## **GULF EQUIPMENT SUBDIVISION**

APPLICATION NUMBER 2 DATE January 6, 2011

REQUEST Subdivision

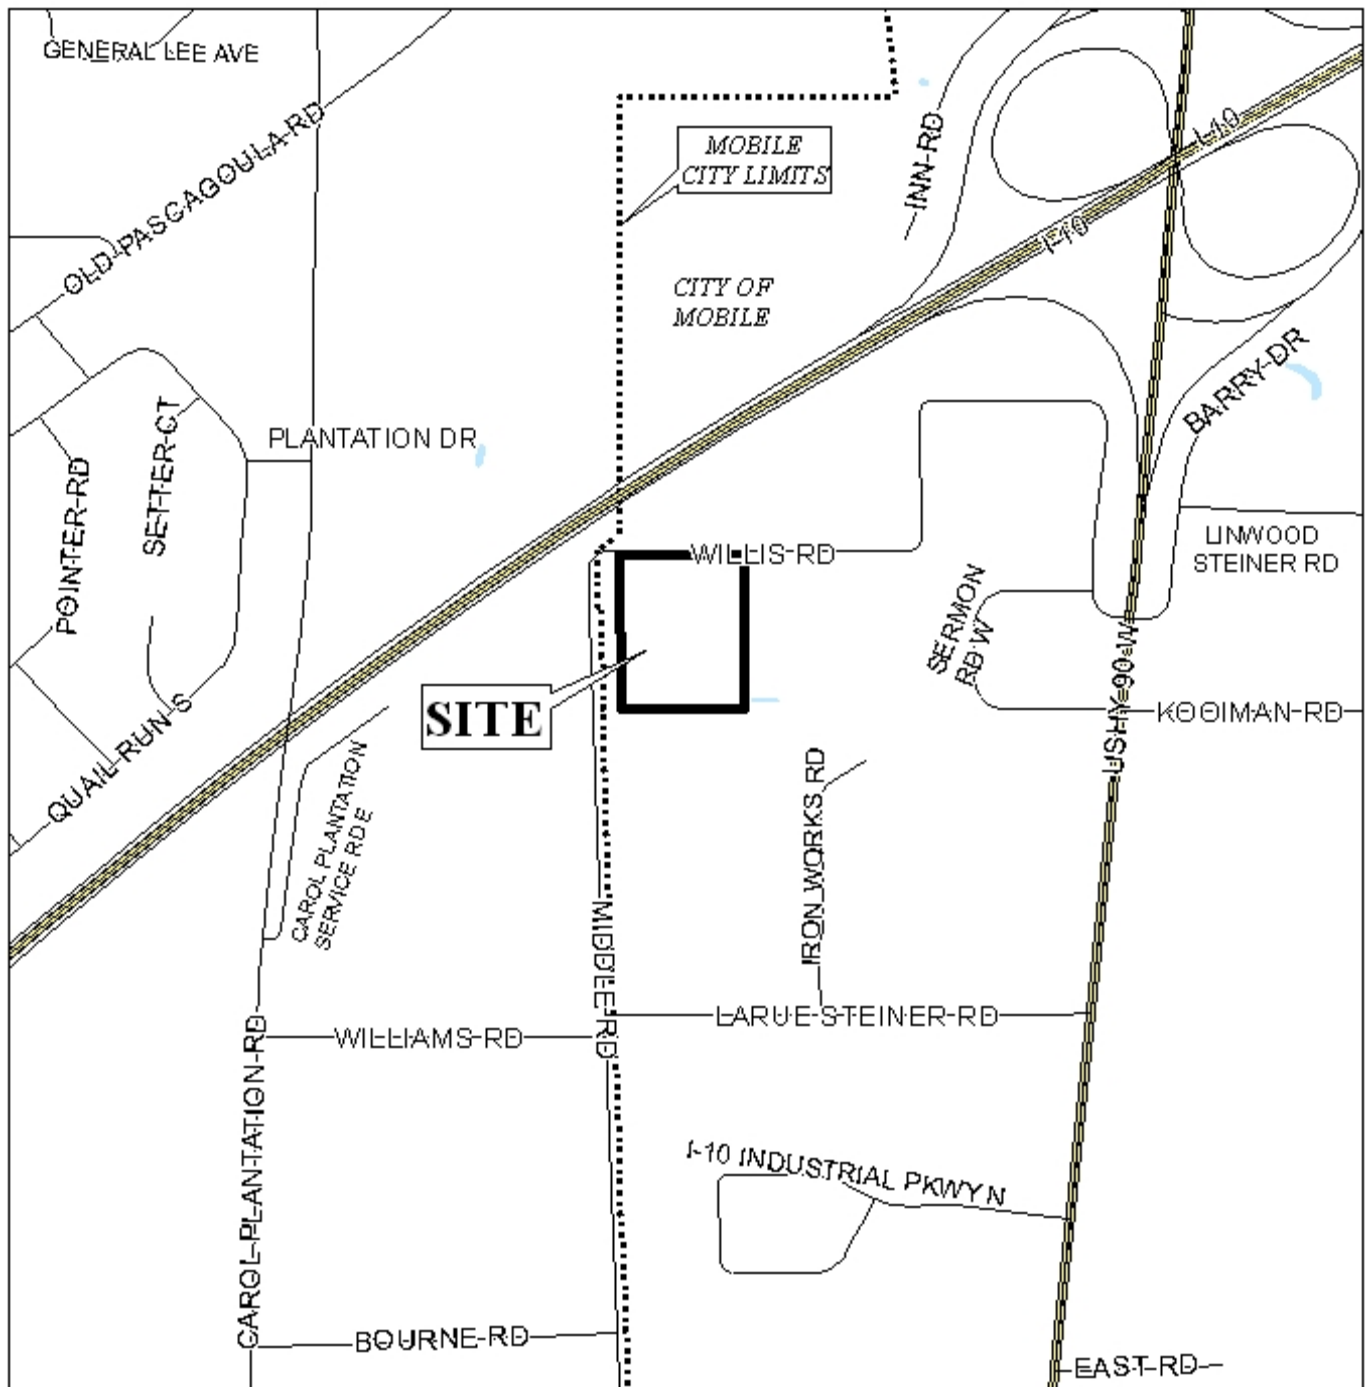
Engineering Comments: The width, location and alignment of the proposed drainage easement subject to review and approval by the City Engineer. Need to provide an easement for the creek crossing the property. Show Mobile City Limits on the Final Plat. Due to the undersized drainage system and history of flooding during rain events at the downstream location at Larue Steiner, detention (100 year storm with 10 year release) will be required for any increase in impervious area. Any work performed in the right of way (including easements) will require a right of way permit, in addition to any required land disturbance permits. Drainage from any new dumpster pads cannot discharge to storm sewer; must have connection to sanitary sewer.

The 25-foot minimum building setback line, required in Section V.D.9., is illustrated on the preliminary plat, and should be retained on the Final Plat, if approved.

It appears that a portion of the site may contain wetlands and be within the floodplain for Rabbit Creek. The potential presence of wetlands and floodplains indicate that the area may be environmentally sensitive; therefore, the approval of all applicable federal, state and local agencies would be required prior to the issuance of any permits or land disturbance activities.

- 1) retention of the labeling of the lot with its size in square feet;
- 2) placement of a note on the Final Plat stating that development of the site must be undertaken in compliance with all local, state and Federal regulations regarding endangered, threatened or otherwise protected species; and

- 3) placement of a note on the Final Plat stating that any lots which are developed commercially and adjoin residentially developed property must provide a buffer, in compliance with Section V.A.8. of the Subdivision Regulations.

- 4) retention of the 25-foot minimum building setback line along all right-of-way frontages;
- 5) placement of a note on the Final Plat limiting the development to one curb cut to Willis Road, with the size, design, and location of all curb cuts to be approved by Mobile County Engineering and conform to AASHTO standards;

- 6) compliance with Engineering comments (*The width, location and alignment of the proposed drainage easement subject to review and approval by the City Engineer. Need to provide an easement for the creek crossing the property. Show Mobile City Limits on the Final Plat. Due to the undersized drainage system and history of flooding during rain events at the downstream location at Larue Steiner, detention (100 year storm with 10 year release) will be required for any increase in impervious area. Any work performed in the right of way (including easements) will require a right of way permit, in addition to any required land disturbance permits. Drainage from any new dumpster pads cannot discharge to storm sewer; must have connection to sanitary sewer.*)

- 7) approval of all applicable federal, state and local agencies prior to the issuance of any permits or land disturbance activities;
- 8) correction of legal description "Southeast corner" should be "Southwest corner"; and
